PARTS & SERVICE NEWS

REF NO.	AA01164
DATE	August 29, 2001

SUBJECT: CAB WINDSHIELD REPLACEMENT

PURPOSE: Add brackets to cab that reinforce window mounting to cab

Figure 4

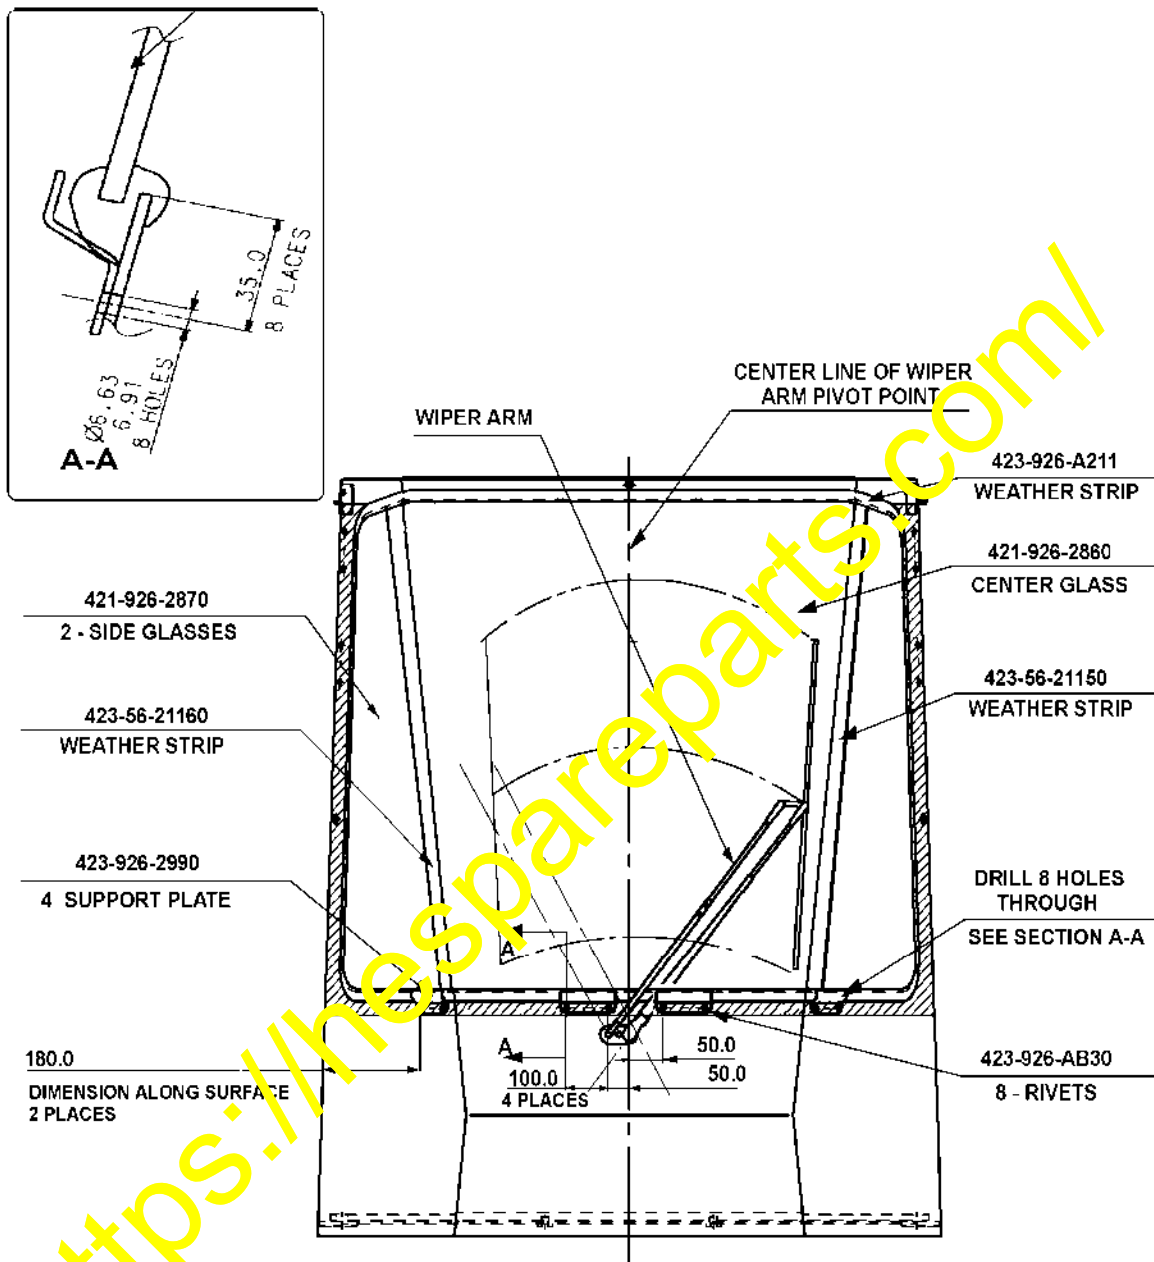
4. Remove the broken windshield and clean the glass debris from the rubber trim. Clean all the edges of the new windshield with a sharp knife.

Clean all edges with a sharp knife
